TECHNICAL SPECIFICATION CHANGE REQUEST NO. 61 (APPENDIX A)

Page Replacement

Delete and insert the pages in Appendix A of Operating License DPR-72 as indicated below:

FIGURE 2.1-2  
 REACTOR CORE SAFETY LIMIT

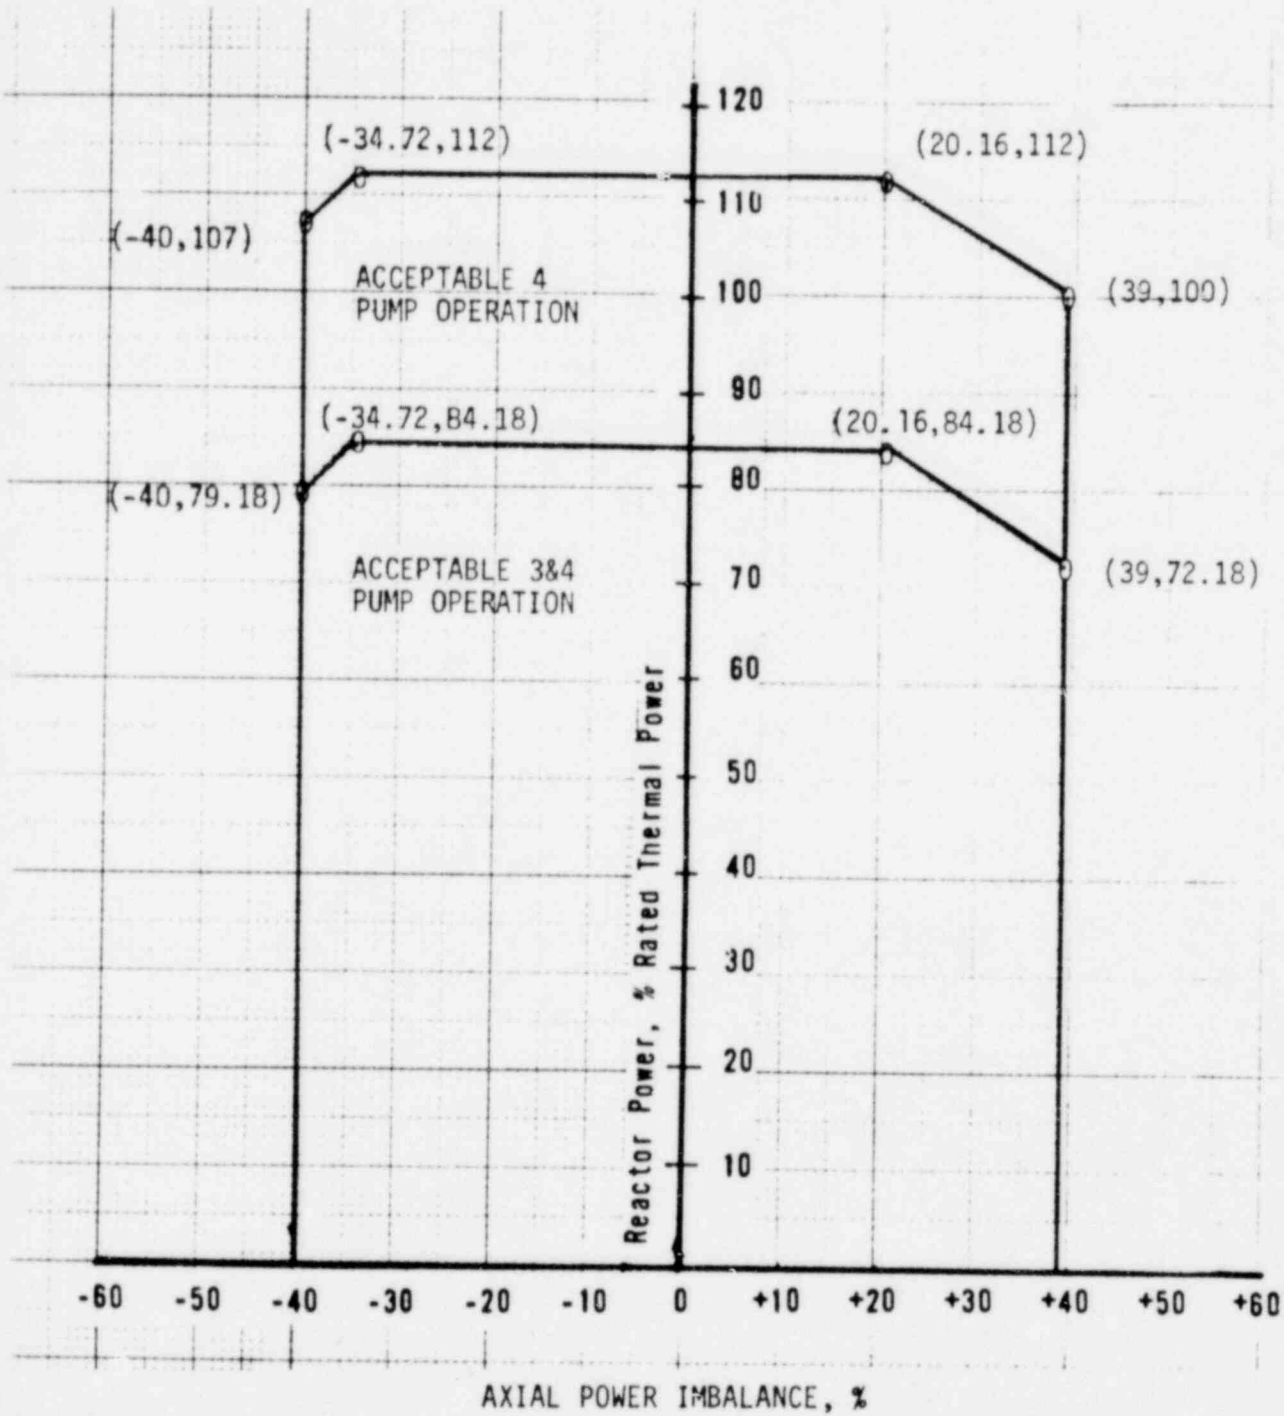
These changes include changing: 1) the Reactor Core Safety Limit for Reactor Thermal Power and Axial Power Imbalance and associated Bases; 2) the Limiting Safety System Settings and associated Bases; 3) the Regulating and Axial Power Shaping Rod Group insertion limits; 4) the figures that specify the power level cutoff for Xenon reactivity; 5) the Axial Power Imbalance Envelopes; 6) the Quadrant Power Tilt Limits; and 7) the DNB Margin Limits; 8) the Shutdown Margin requirements for Modes 4 and 5.

- a. Pages 2-3, 2-5, 2-7, B2-1, B2-5, B2-6, B2-8, 3/4 1-27, 3/4 1-28, 3/4 1-29, 3/4 1-30, 3/4 1-38, 3/4 1-39, 3/4 2-2, 3/4 2-3, 3/4 4-1: The flux/ $\Delta$ flux envelopes, flux/flow trips, regulating rod group insertion limits, axial power shaping rod group insertion limits, and axial power imbalance envelopes reflect revised nuclear parameters as a result of the Cycle 3 reload.
- b. Page 3/4 2-11: Tilt limits were reduced to reflect increased detector depletion.
- c. Page 3/4 2-13: Flow rates were revised to reflect the values used in the analyses.
